CURRAGH RESOURCES - FARO MINE

REPORT  
ON  
1987 SITE VISIT

Prepared For:  
NORTHERN AFFAIRS PROGRAM  
Whitehorse, Y.T.

July, 1987  
G052-4

Photo 25: Glacial till waste dump at the existing Grum lagoon is unstable.

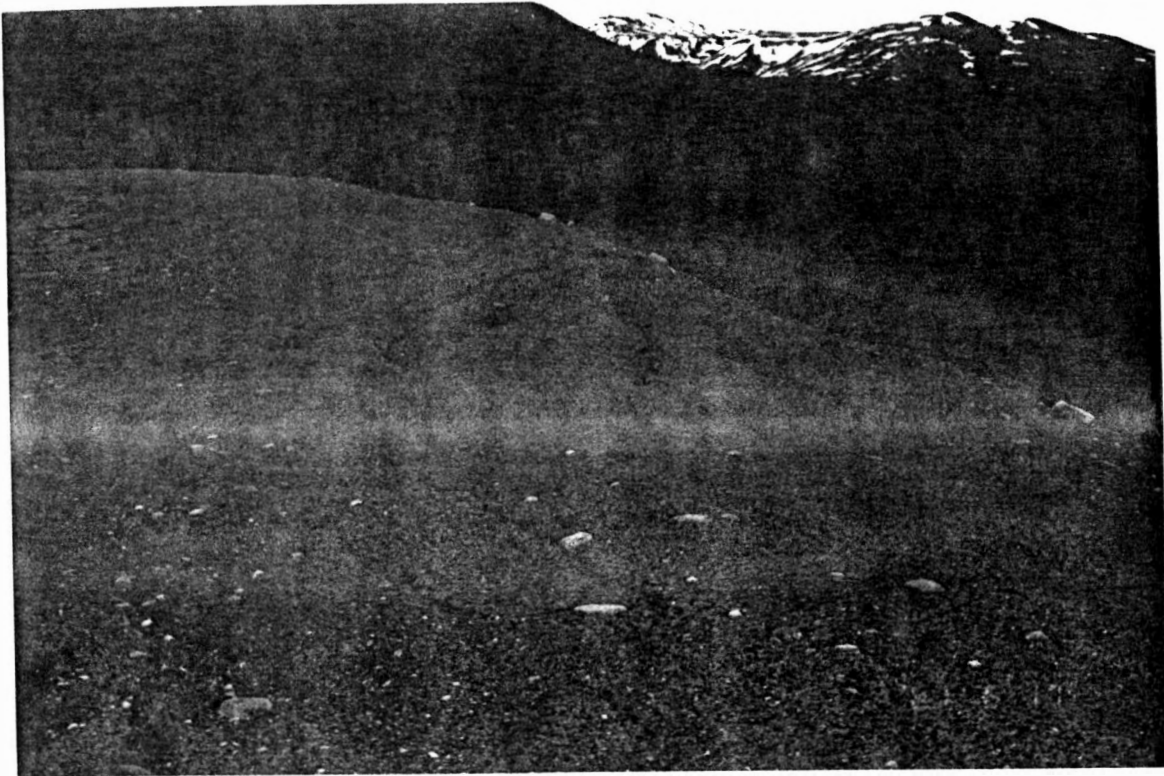
- ° A large volume of till overburden would be apparently placed into the Grum waste pile. It is of interest to note that an existing till waste located at the Grum lagoon is unstable (Photo 25).

Photo 26: Vangorda Creek at the proposed diversion dam location.

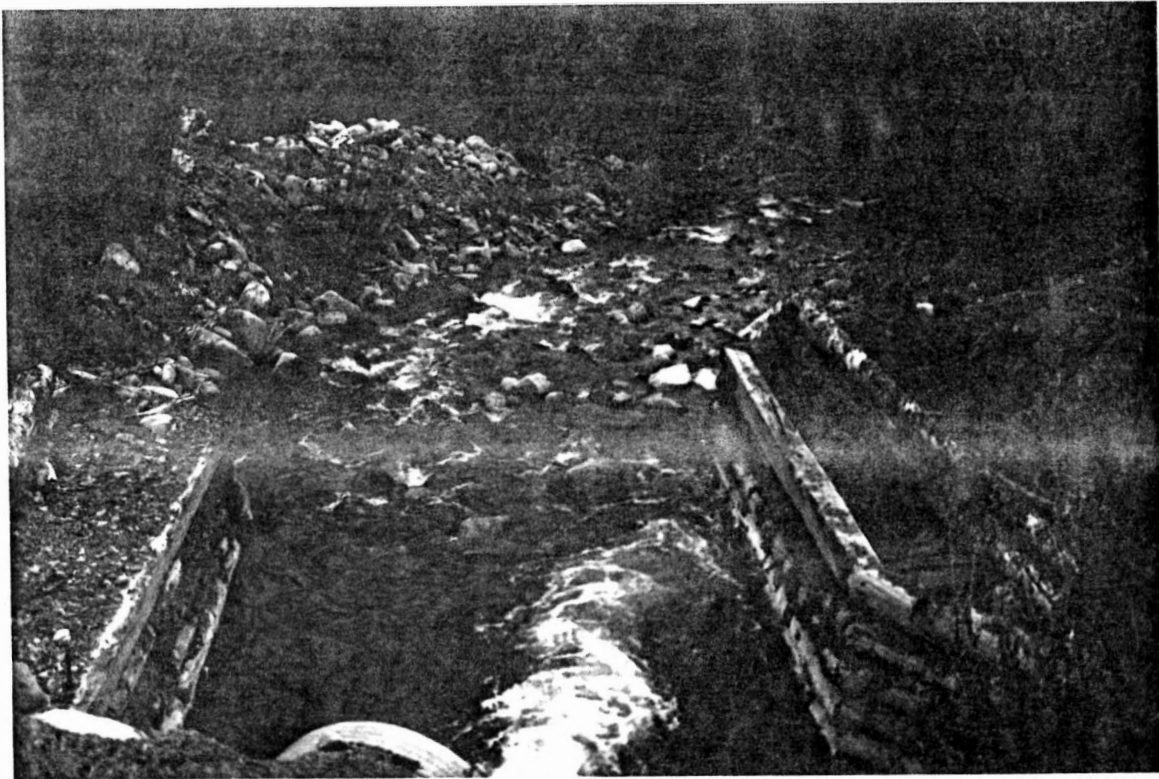
- ° Proposed diversion of Vangorda Creek (Photo 26) will be a major problem at the abandonment stage of the operation. It will be impossible to ensure the long-term integrity of the diversion dam and diversion canal without continuous maintenance.
